FILE: CSSTP-0007-00(319) Hall Co.
P.I. No.: 0007319
SR 347 Lanier Island Pkwy

SUBJECT: IMPLEMENTATION OF VALUE ENGINEERING STUDY ALTERNATIVES

SUBJECT Response to Value Engineering Study Alternatives

SUBJECT: RESPONSE TO VALUE ENGINEERING STUDY ALTERNATIVES

- R-9.0 (Eliminate realignment of New Bethany Road at existing SR 347)

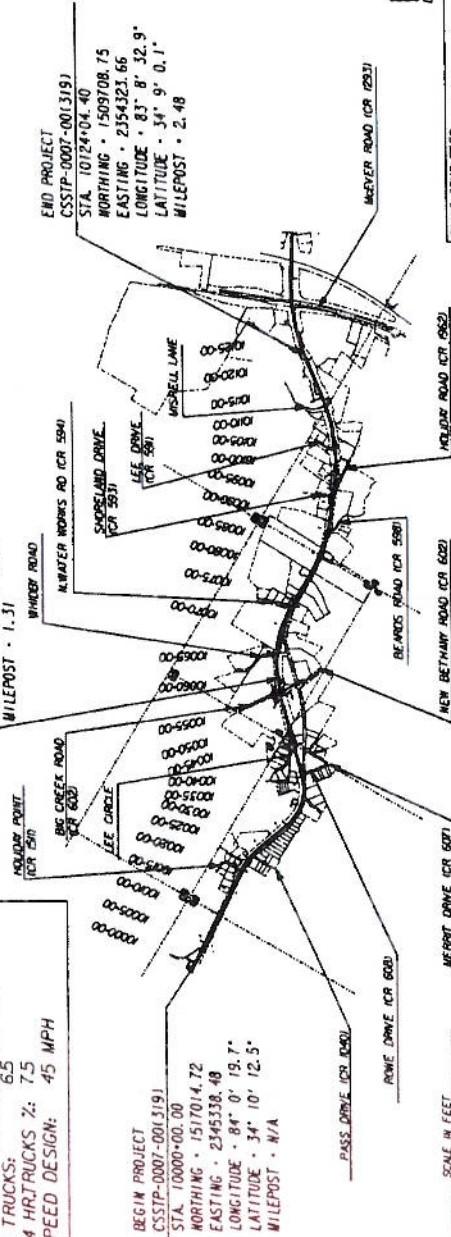
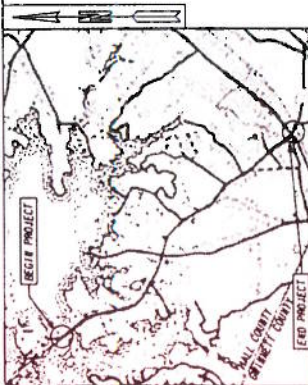
The following VE Study recommendations can be analyzed since the analysis involves a comparison between intersection types. The analysis includes comparing the proposed condition – Unsignalized four-leg intersection (stop control on minor-road approaches) (4ST) with the VE Study recommendation – Unsignalized three-leg intersection (stop control on minor-road approaches) (3ST). The results are presented on the next page:

VE Study Recommendation (3ST)	Proposed Recommendation (4ST)
Total Crashes	0.509	0.544
Fatal and Injury (FI)	0.199	0.194

The proposed intersection recommendation and the VE Study intersection recommendation show less than 1 total crash per year as well as less than 1 injury and fatal crash per year at the New Bethany Road / SR 347 (existing or proposed) intersection and the Lee Circle / SR 347 (existing or proposed) intersection.
